SUBJECT: ISSUANCE OF AMENDMENT NO. 44 TO FACILITY OPERATING LICENSE
NO. NPF-41, PALO VERDE NUCLEAR GENERATING STATION, UNIT 1,
(TAC NO. 71873)

Amendment No. 44
License No. NPF-41

AMENDMENT NO. 44 TO FACILITY OPERATING LICENSE NO. NPF-41

SAFETY EVALUATION BY THE OFFICE OF NUCLEAR REACTOR REGULATION
RELATED TO AMENDMENT NO. 44 TO FACILITY OPERATING LICENSE NO. NPF-41,
ARIZONA PUBLIC SERVICE COMPANY, ET AL.
PALO VERDE NUCLEAR GENERATING STATION, UNIT 1
DOCKET NO. STN 50-528

FIGURE 3.1-1A
SHUTDOWN MARGIN vs. COLD LEG TEMPERATURE

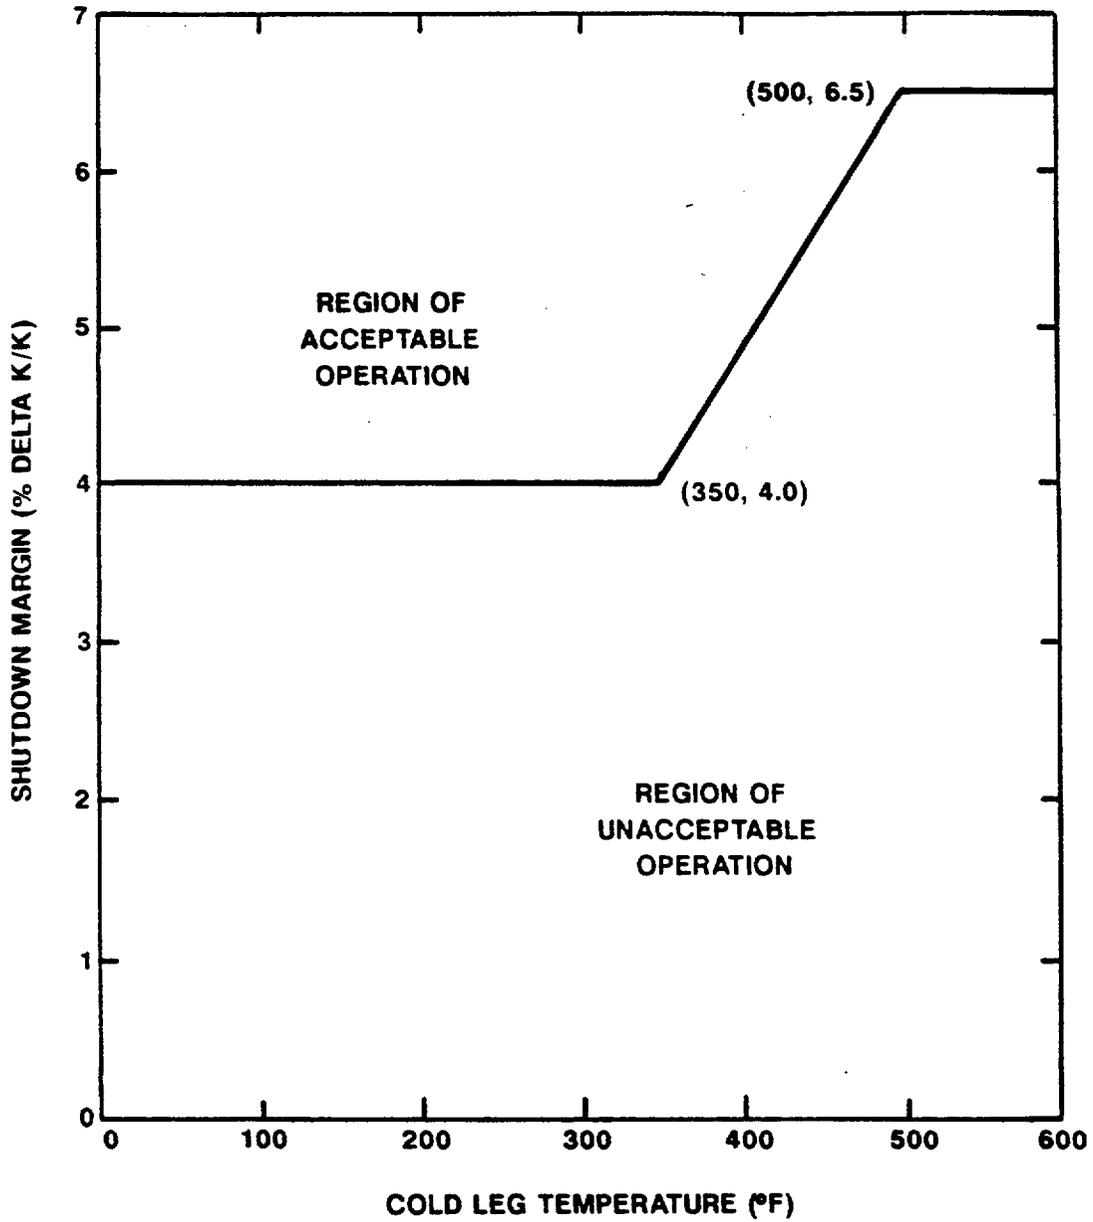
TS Figure 3.1-1A: The proposed change raises the required shutdown margin for cold and hot shutdown conditions from 3.5% delta-k/k to 4.0% delta-k/k to accommodate the requirements for inadvertent deboration. This change is necessary to satisfy regulatory requirements and thus, is acceptable.

FIGURE 3.1-3
CEA INSERTION LIMITS vs. THERMAL POWER
(COLSS IN SERVICE)

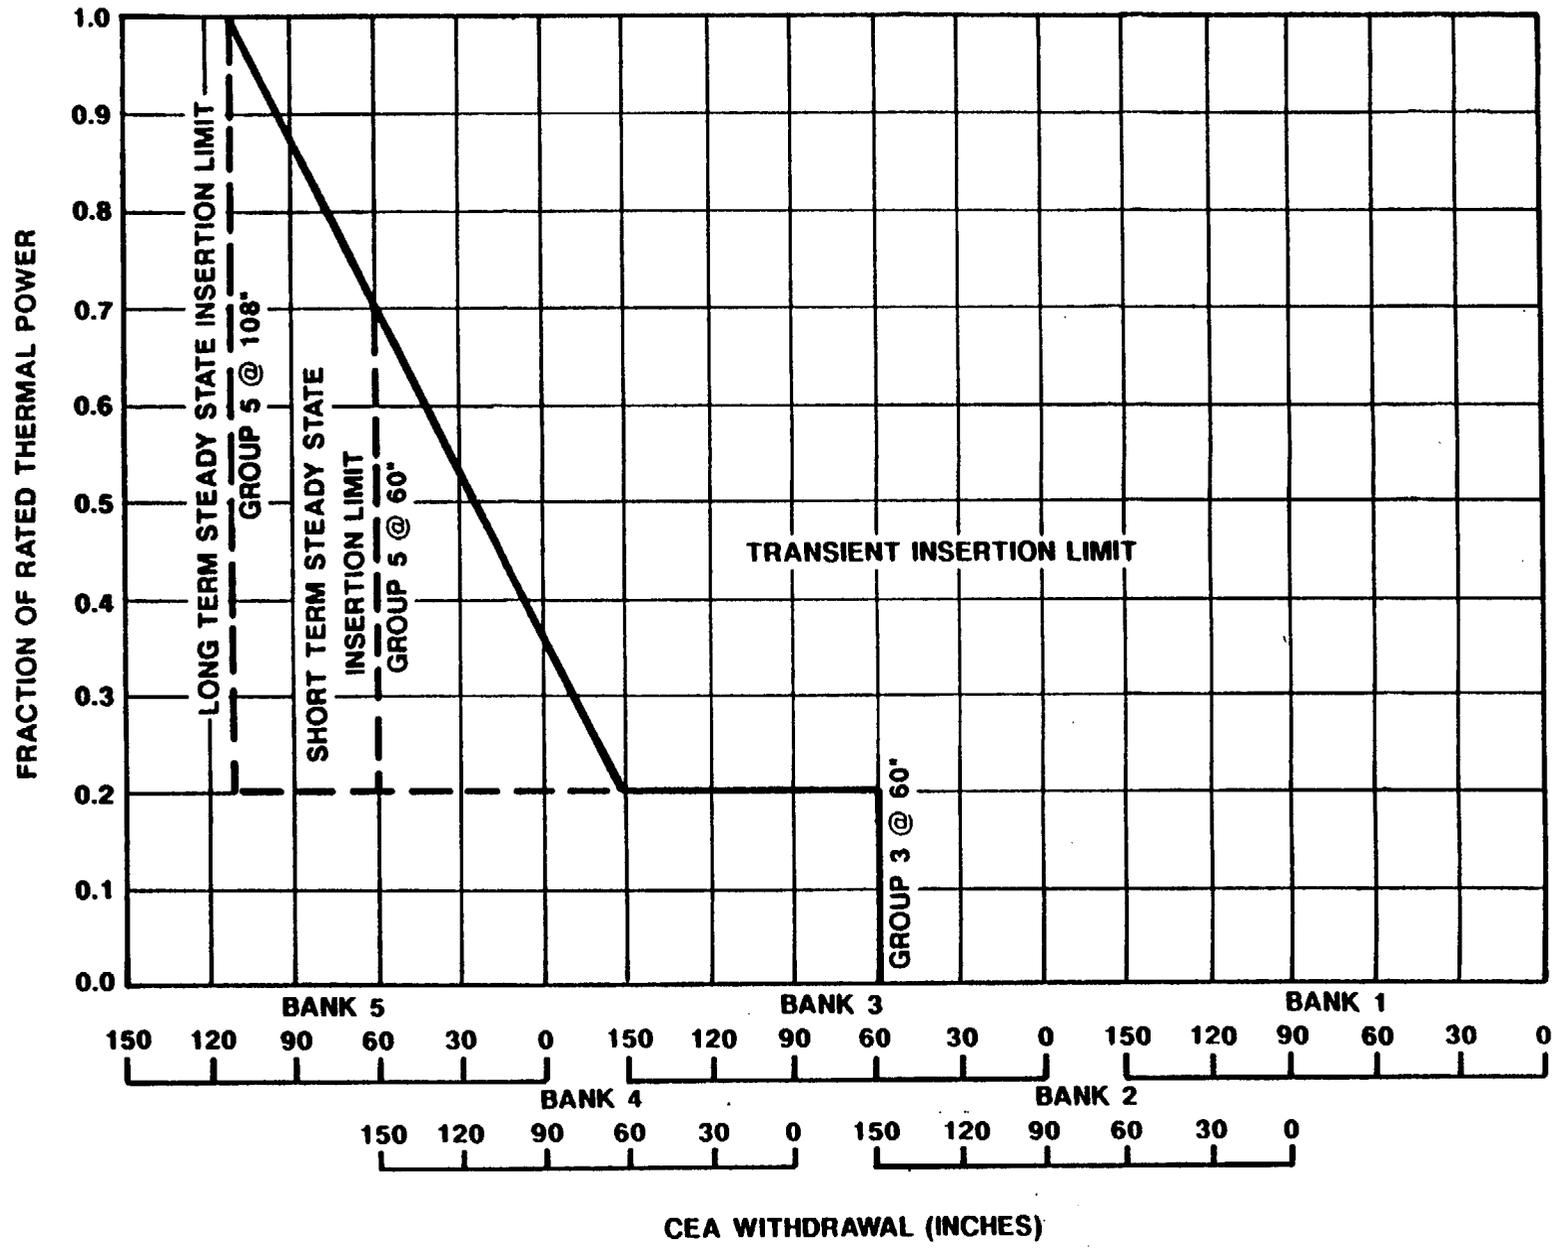
TS Figures 3.1-3 and 3.1-4: The proposed changes revise the curves of the transient insertion limit lines. These changes are required to make the Technical Specifications consistent with the Cycle 3 Safety analyses. Thus, the proposed changes are acceptable.

FIGURE 3.2-1A
 AZIMUTHAL POWER TILT LIMIT vs. THERMAL POWER
 (COLSS IN SERVICE)

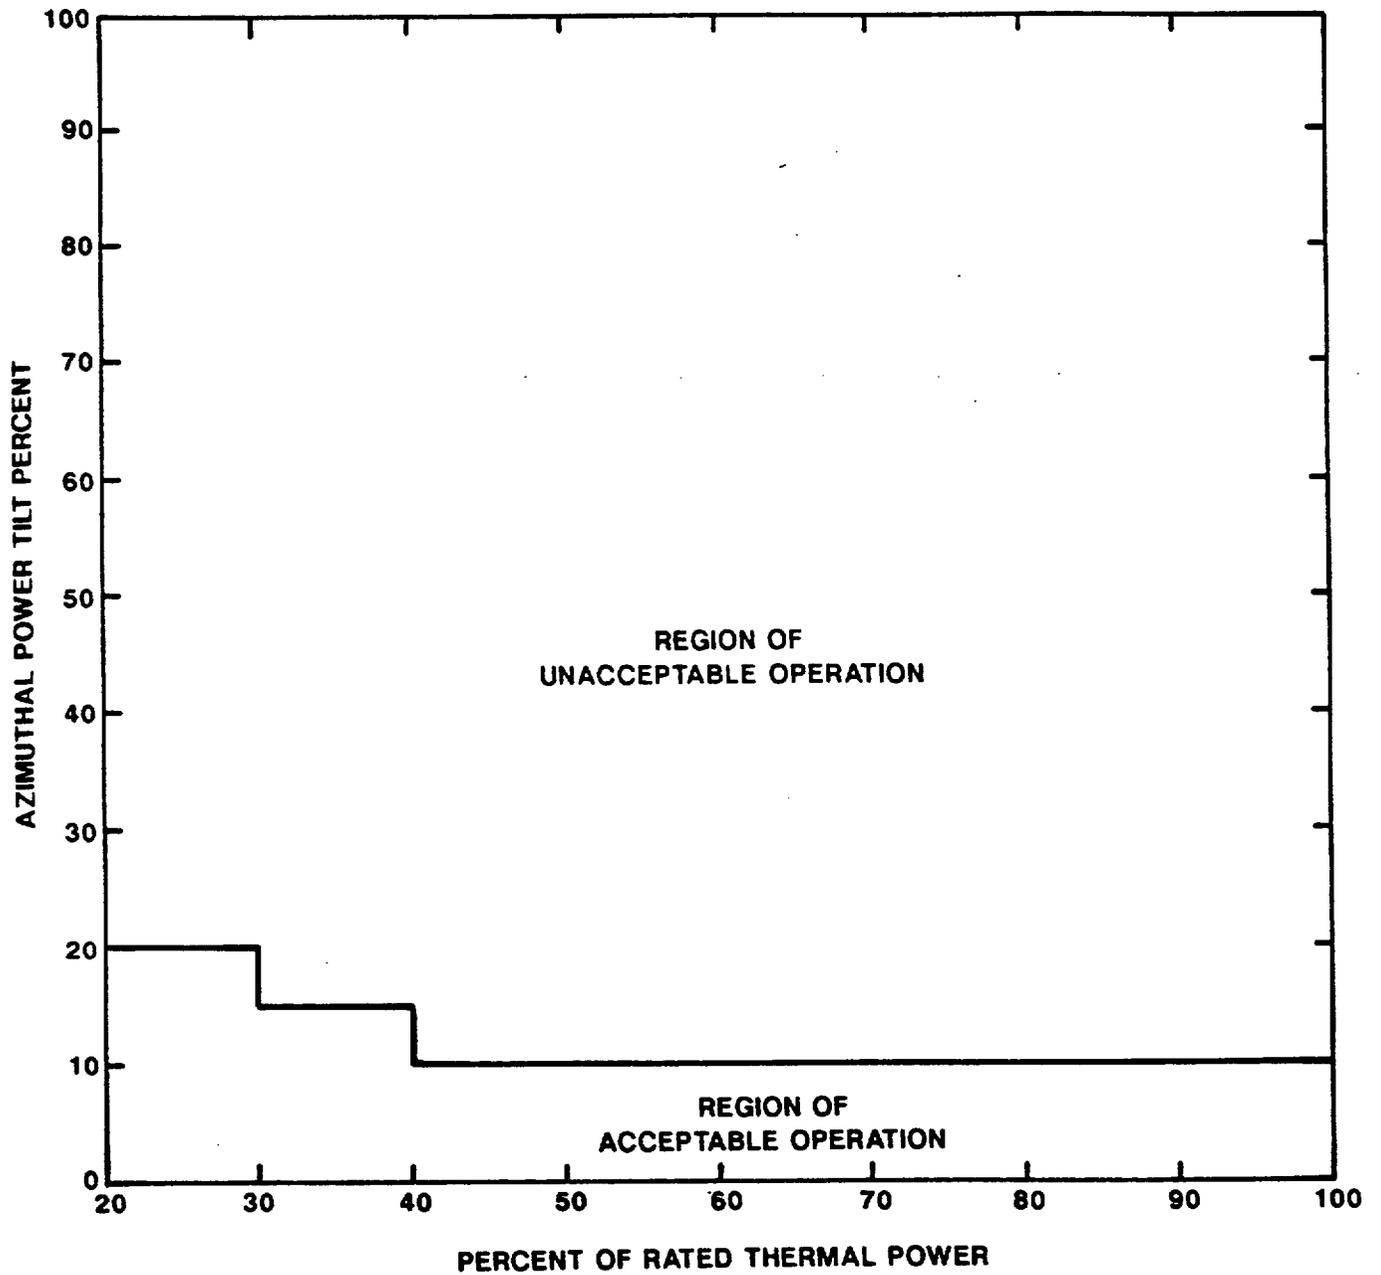
TS Figure 3.2-1A: The proposed change relaxes the azimuthal power tilt operating limits with the core operating limit supervisory system in operation, to avoid lengthy delays in increasing power. When the core operating limit supervisory system is in operation, reactor operation within the analysis limits is assured, therefore, the proposed amendment is acceptable.

FIGURE 3.2-2
DNBR MARGIN OPERATING LIMIT BASED ON CORE PROTECTION CALCULATORS
(COLSS OUT OF SERVICE, CEAC'S OPERABLE)

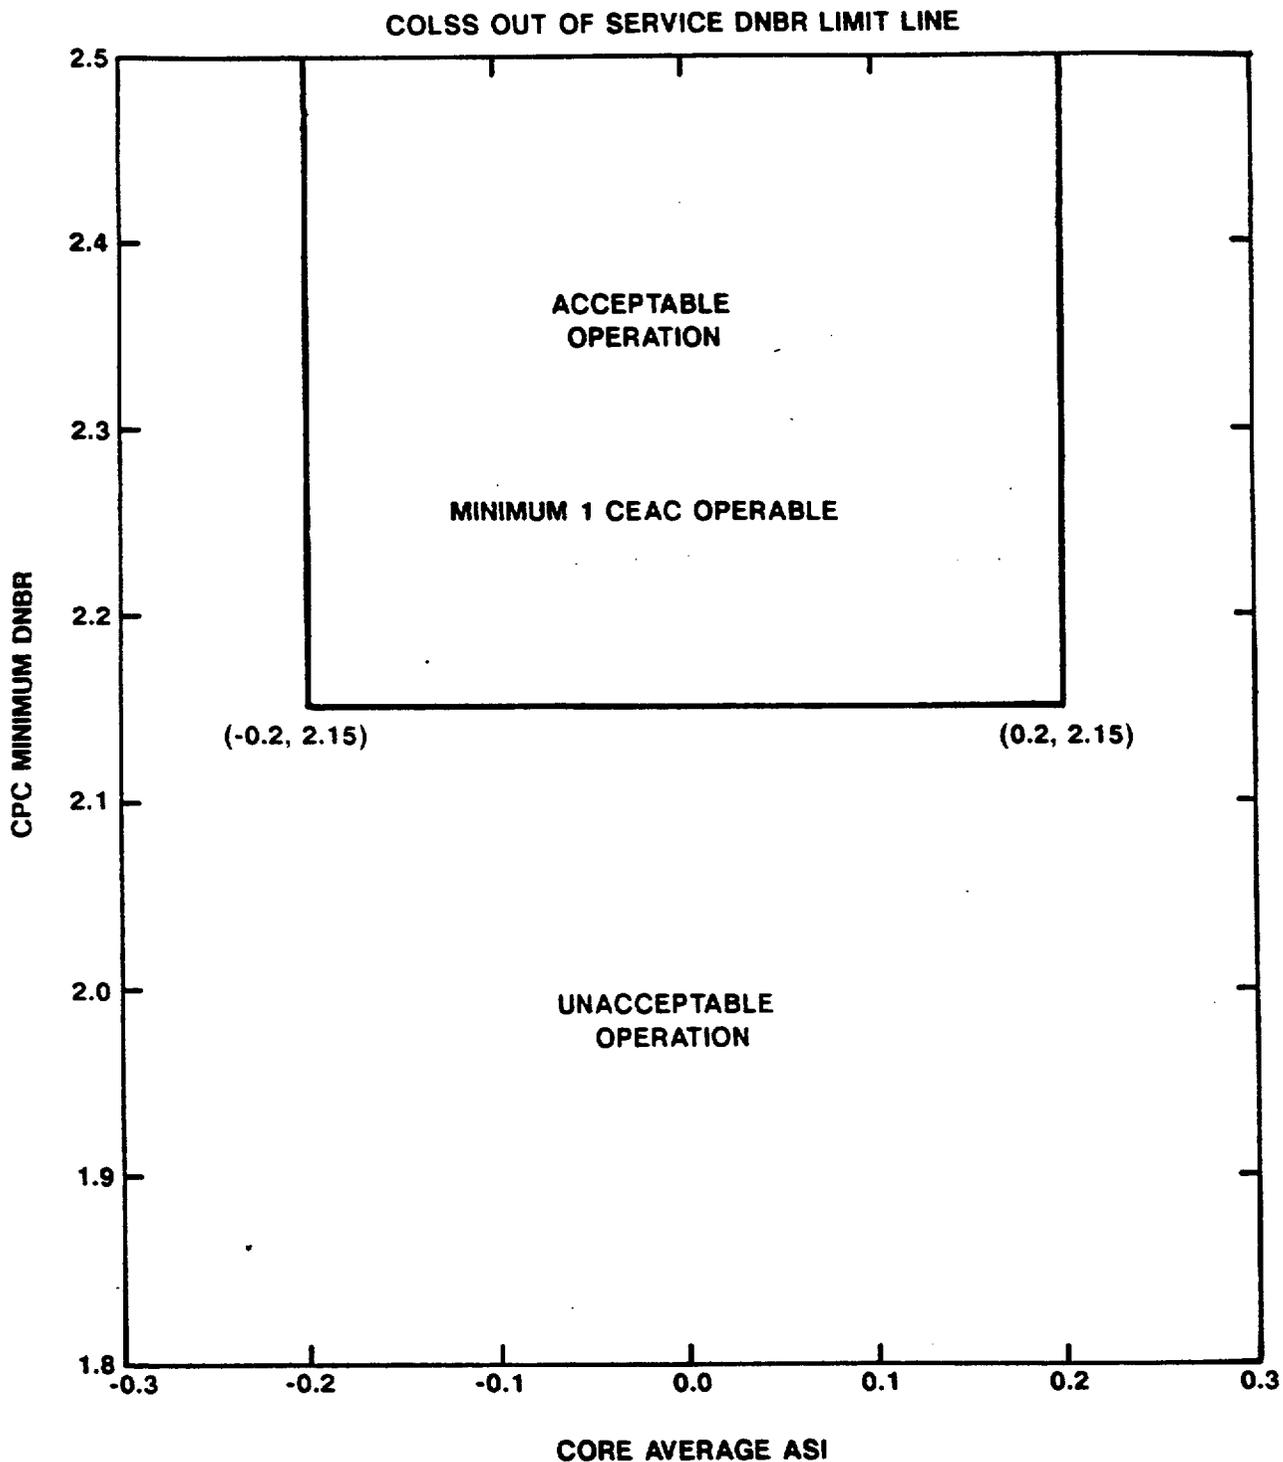
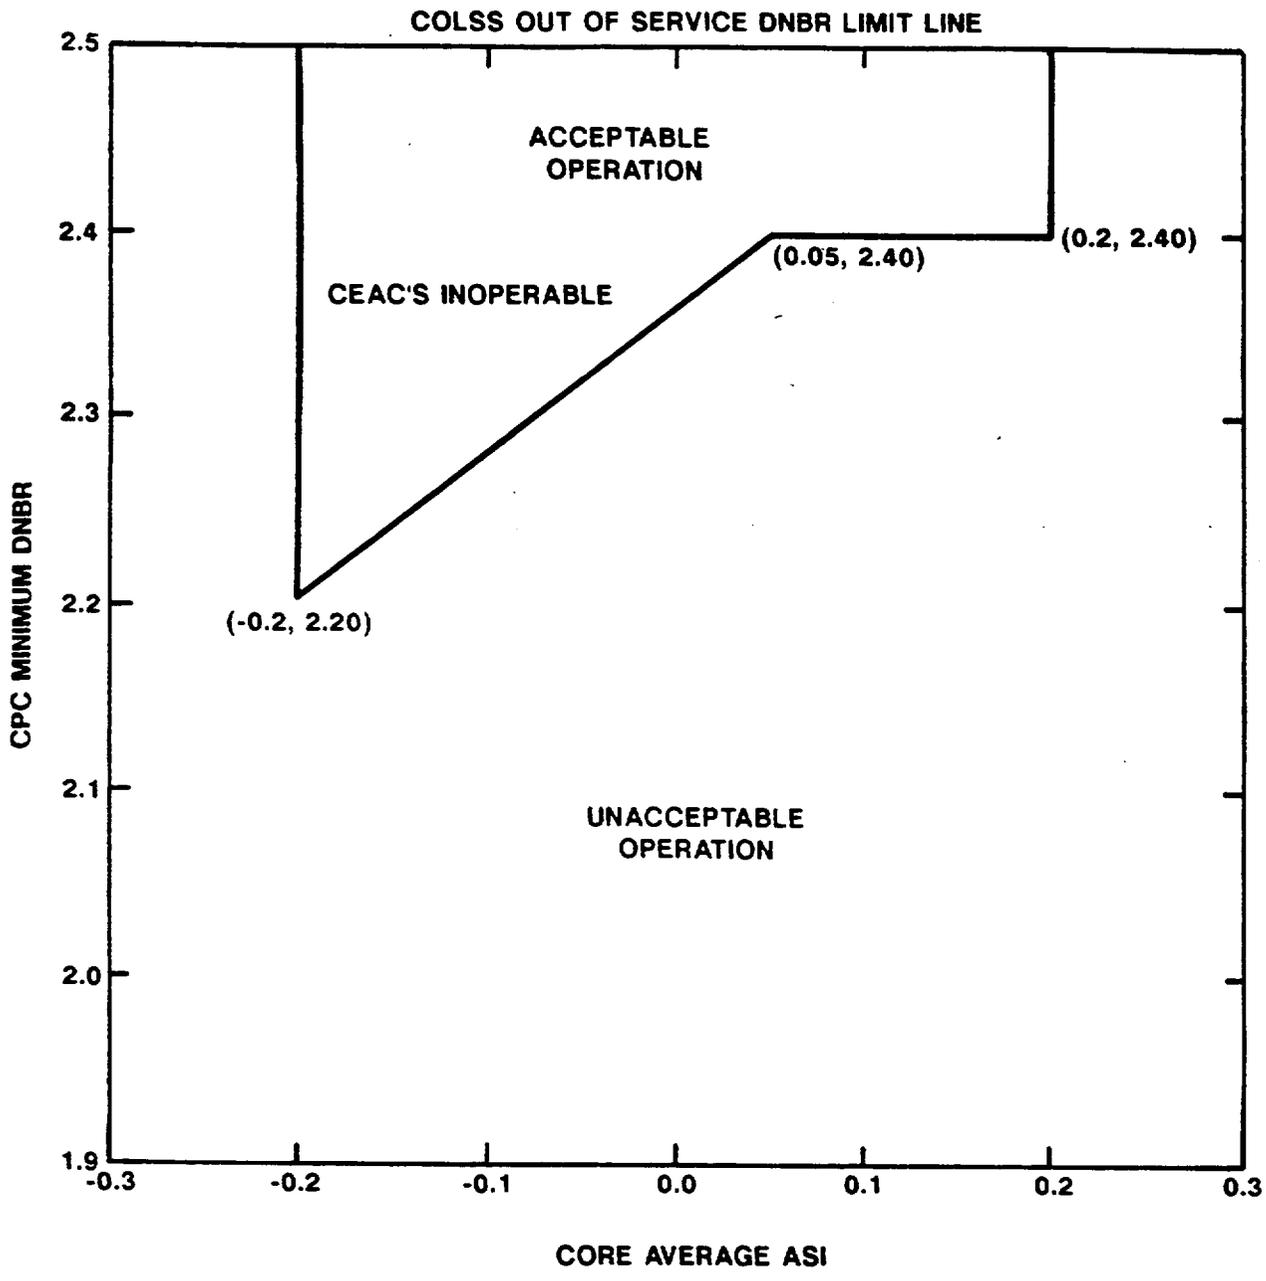
TS Figures 3.2-2 and 3.2-2A: The proposed changes revise the DNBR limit curves for combinations of CEACs inoperable with COLSS inoperable. These revisions are required to reflect cycle-specific parameter changes due to core loadings. The changes are required to ensure that the Technical Specifications are consistent with the safety analyses for Cycle 3, and thus, are acceptable.
